Since this SP review is just for approval of the early/overlot grading, please remove curb and gutter, roads, buildings, and utilities (unless installation of utilities is also requested with early grading, SWMP states "no.").

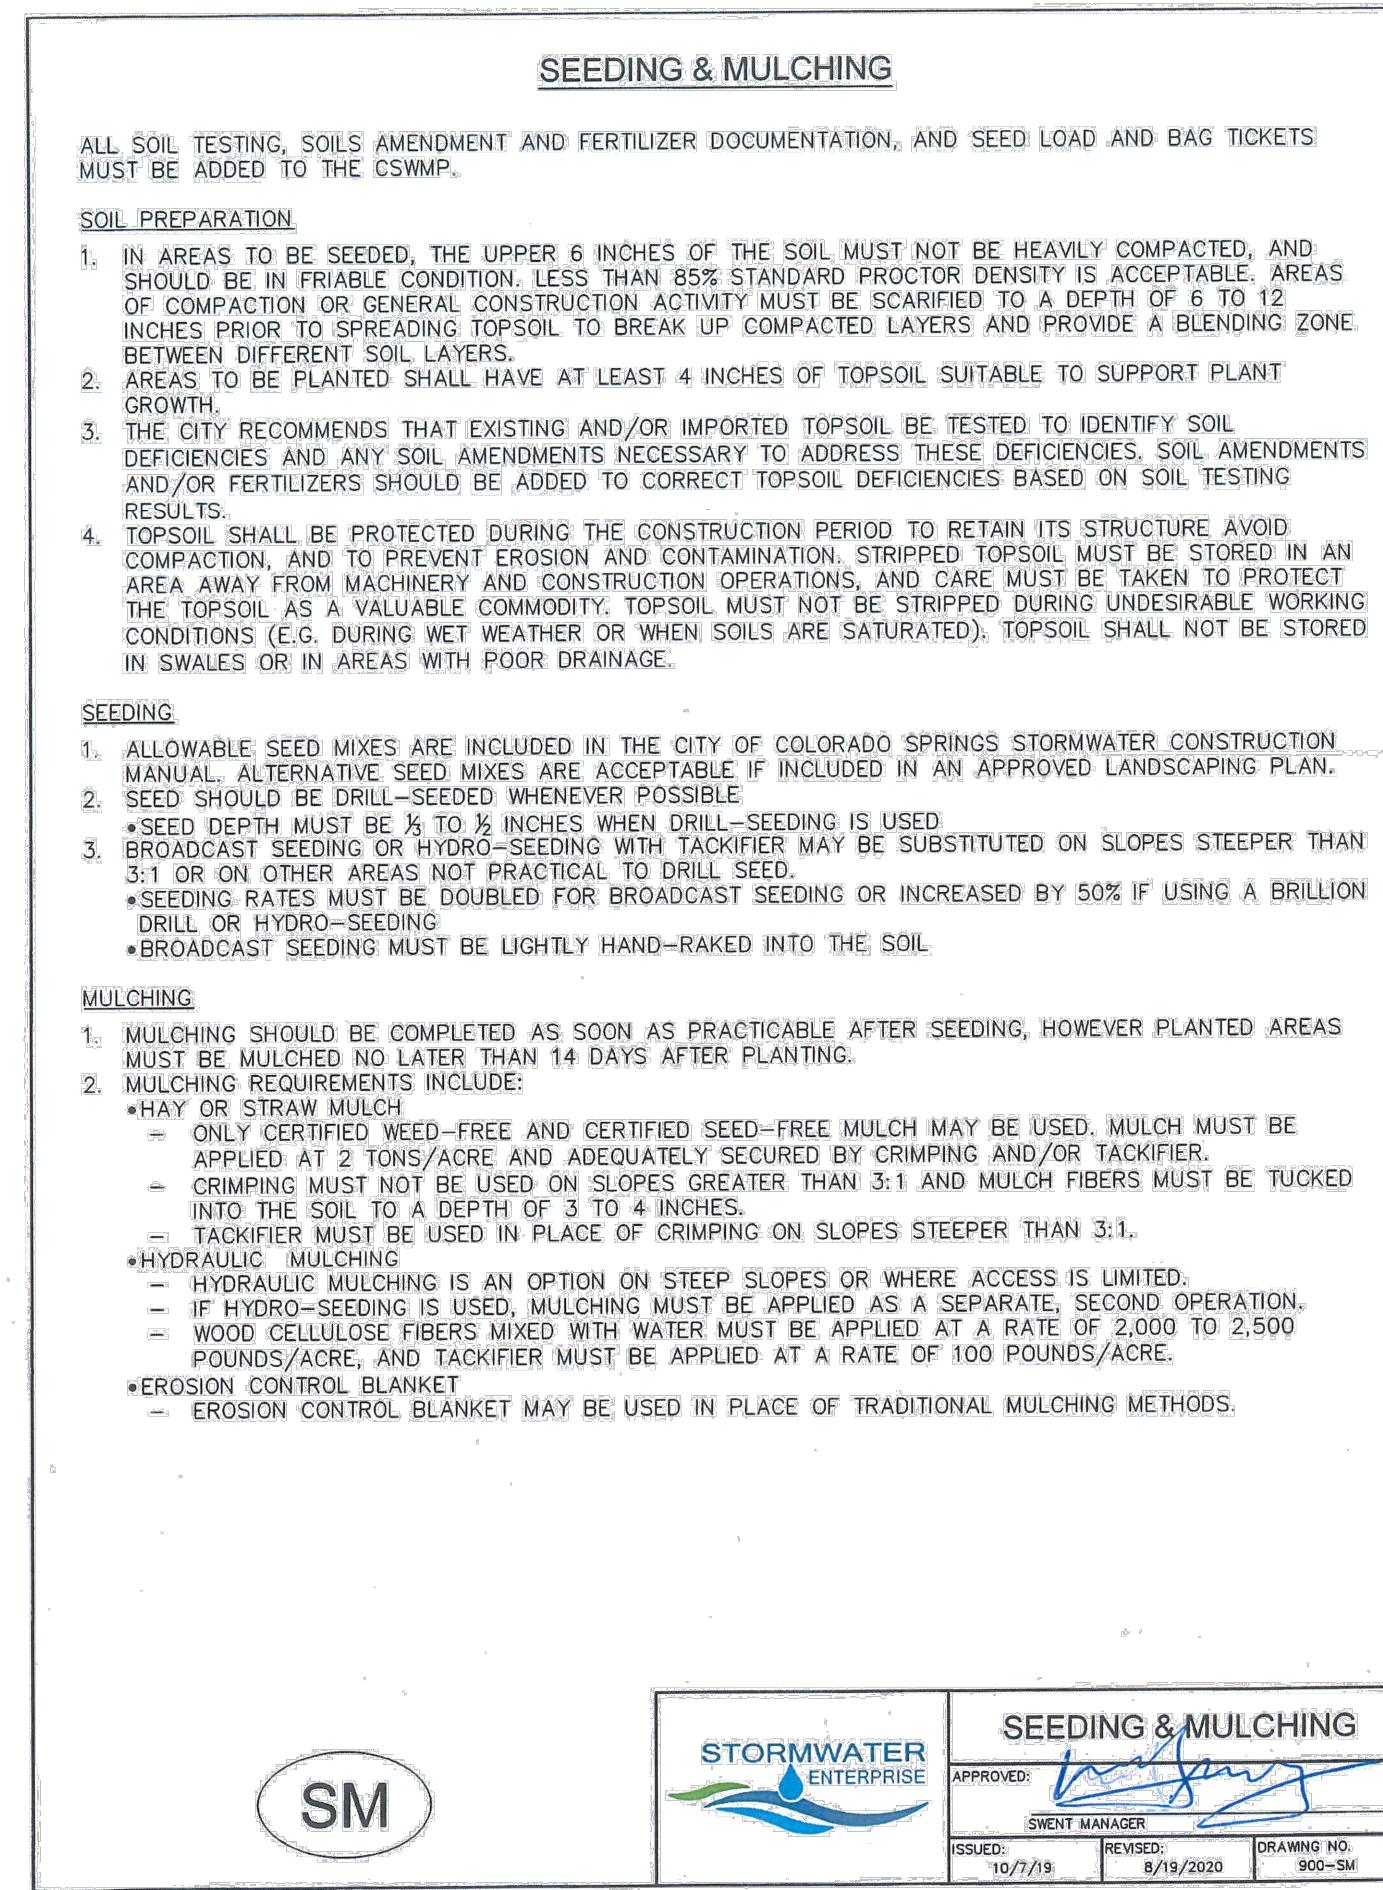
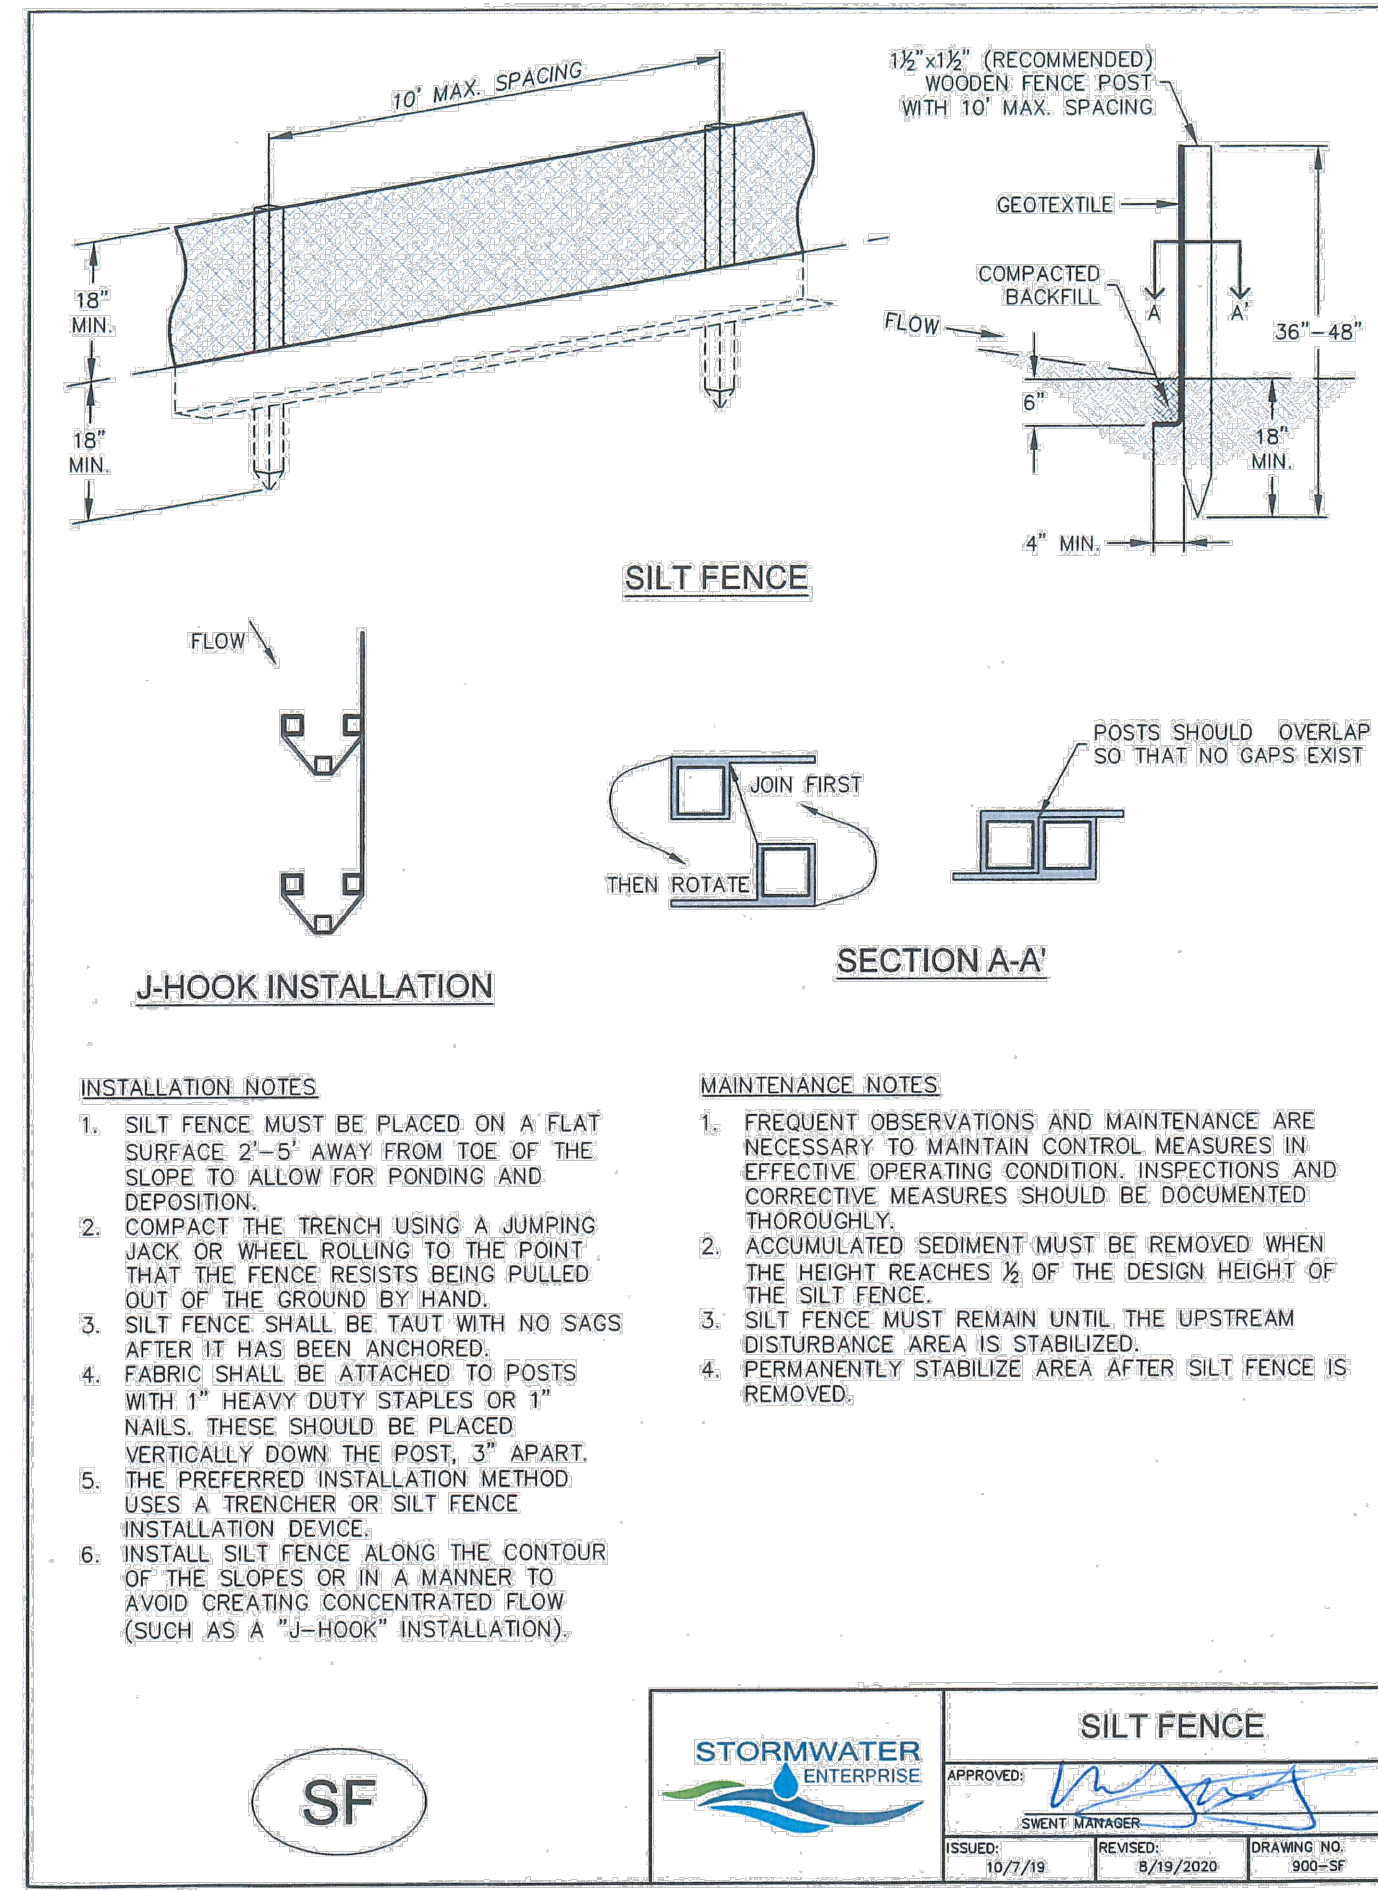
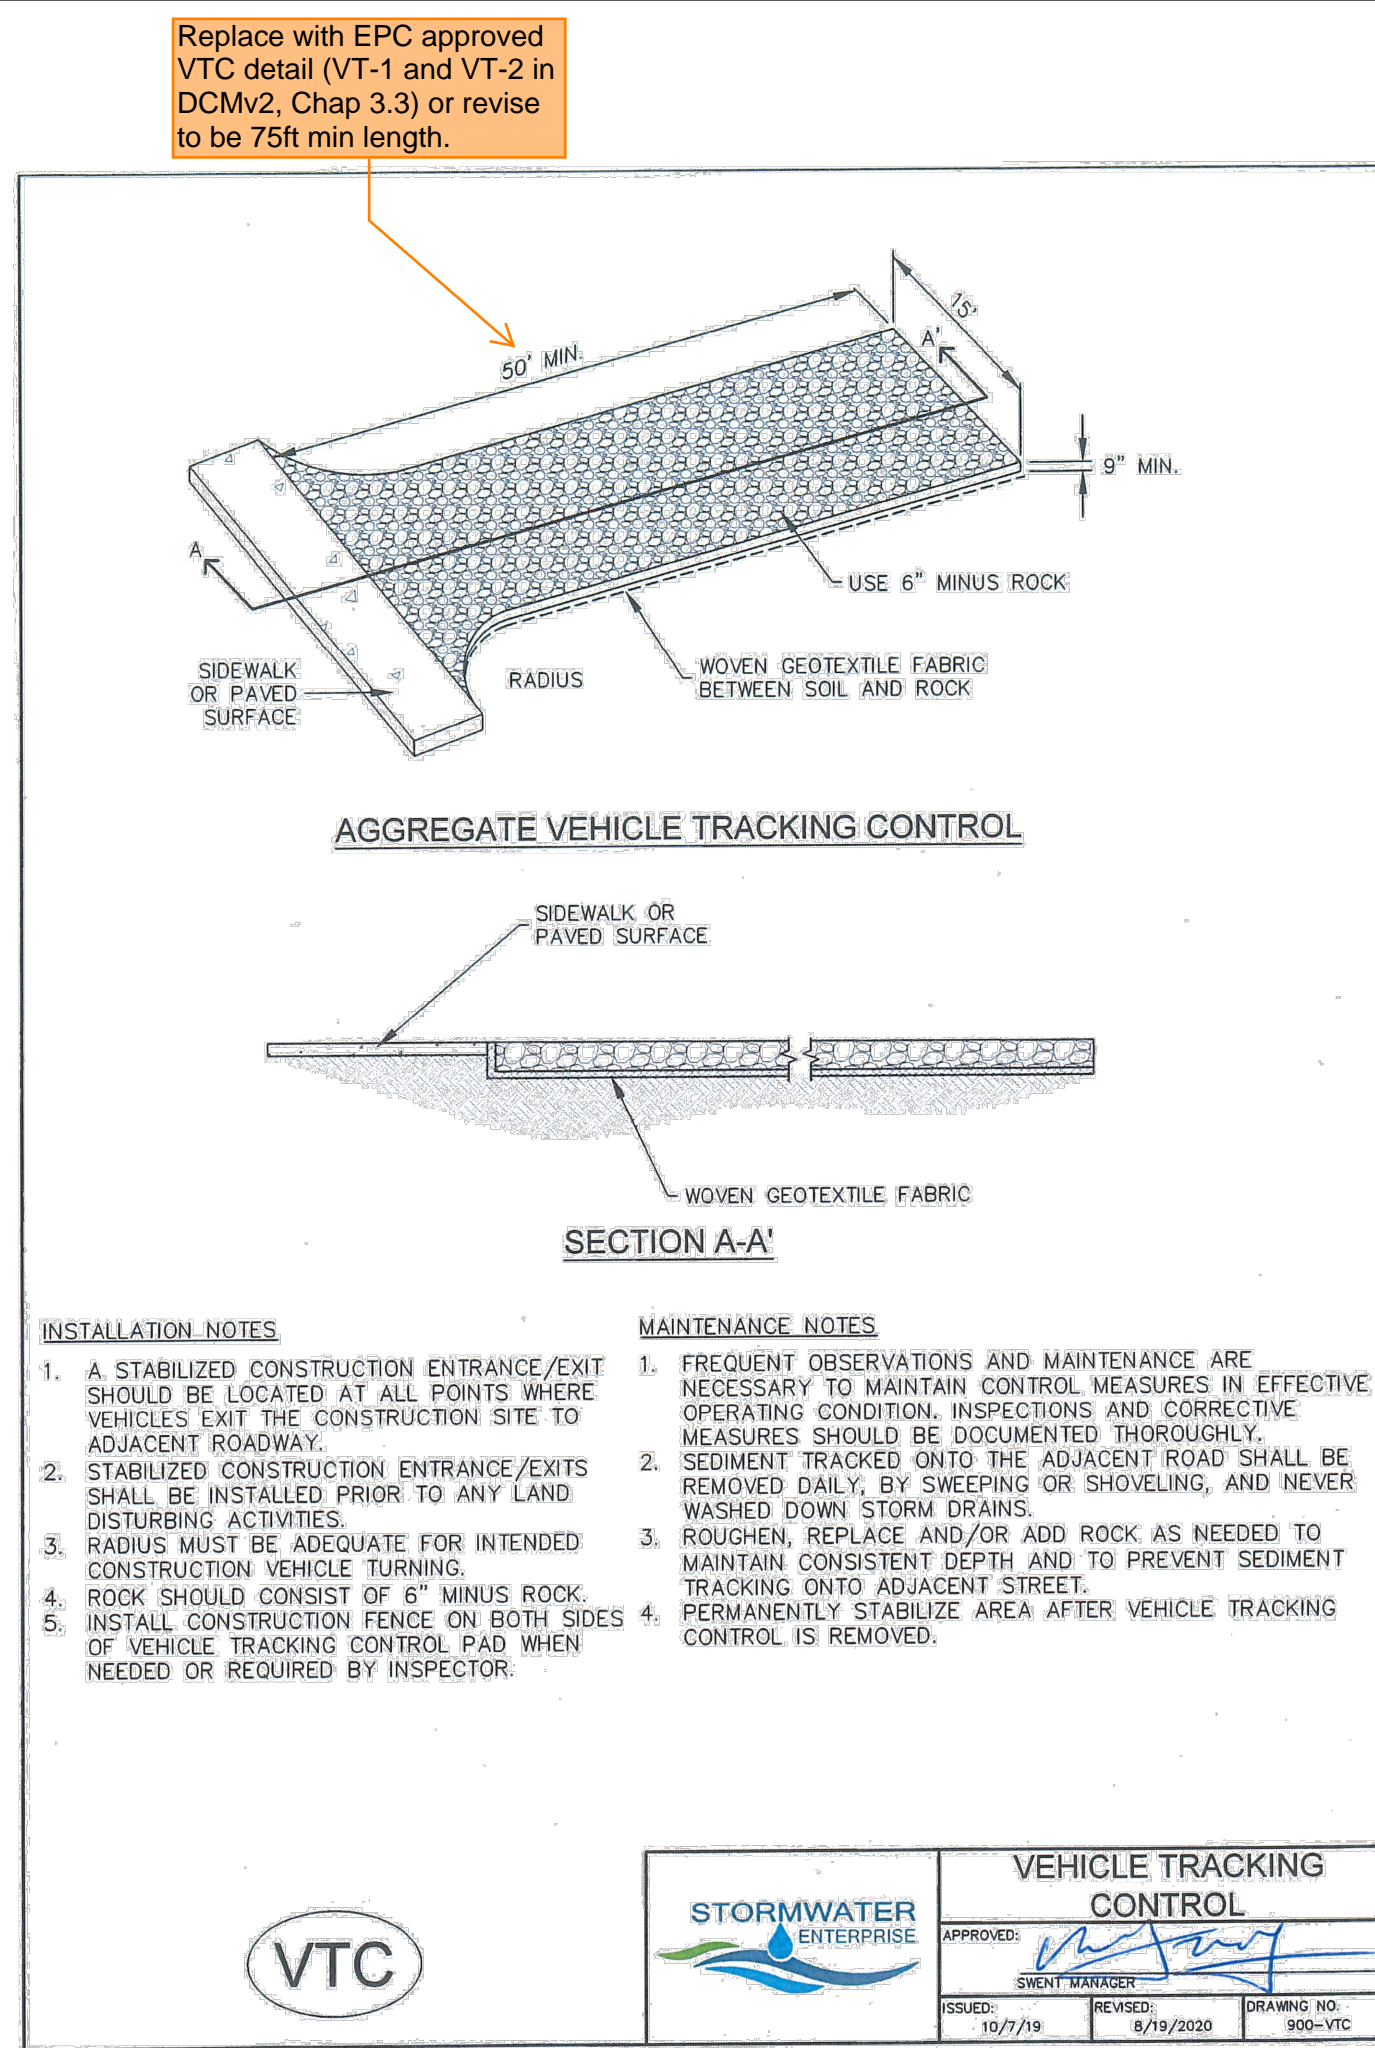
Please address the following GEC Checklist Items:

- Item b - label adjacent properties/parcels
- Item d - add a Legend
- Item e - show property lines
- Items H and M. If "limits of disturbance" and "construction boundary" are the same, change to "limits of construction/disturbance" or otherwise show as separate line types for each on the legend and figure.
- Item i - add a note about existing vegetation
- Item p - show areas of cut/fill.
- Item s - show drainage flow arrows
- Item v - label all BMPs by phase
- Item w - see comment to the left.

Add a general note: all areas to be vegetated with permanent seeding should also be temporary stabilized via track rolling or some other means.

And show location of temp seeding (2.46ac according to FAE Form).

Be sure to show all grading with LOD/LOC

GEC Checklist Item W. Provide construction fencing, barricades, and/or signage at access points not to be used for construction.

Provide a stabilized access ramp that is a minimum of 15ft wide and no greater than 12% slope, in accordance with DCMv1, Chap 11.2.2.

And provide an access road detail/cross section, including stone sizing and gradation. Show cross slope at 2%.

Provide a County access easement for pond.

Per DCMv1 Chap 11.3.3, adjust pond design to include a min. width of 12ft at top of embankment.

Show as a TSB in the early grading (initial/interim) condition. And provide temp conveyance (if needed) like temp swales to convey all early grading runoff to the TSB.

Typical comment for TSBs: Provide details of temporary sediment basin including riser pipe diameter and perforation sizing, number of rows of holes, required volume, location of outlet pipe and spillway, and tributary area to the sediment basin. And provide contours for sediment basin.

The label in the calcs on pg 50 of the FDR is "South Pond" add this to the report text and dwgs/maps for consistency.
